IN HOUSE REJECTION: KAIZEN

3a.6 Appearance not Good

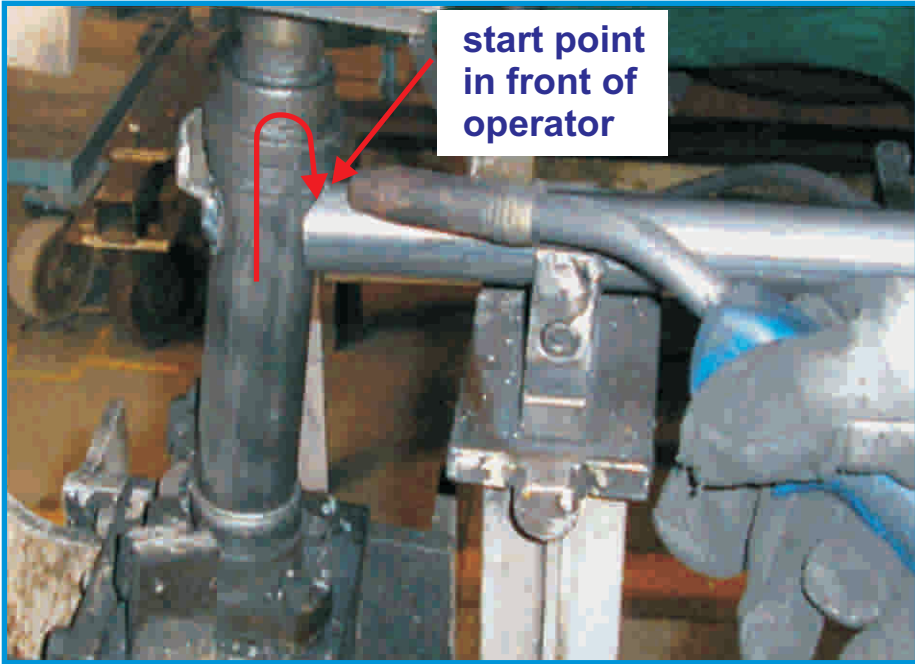
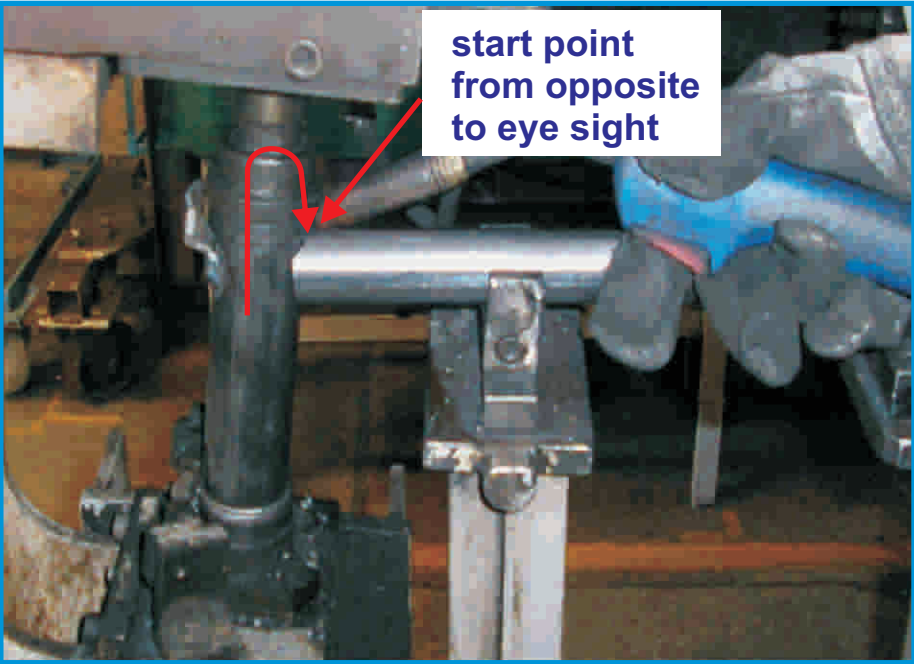
Physical Phenomenon : **CO₂ wire (sticking)**
Due to : Man / Machine / **Method** / Material

Welding joint point not visible to operator.

Root Cause : Difficult to access

Kaizen Idea : Easy to access

Kaizen : Welding position shifted for better accessibility.
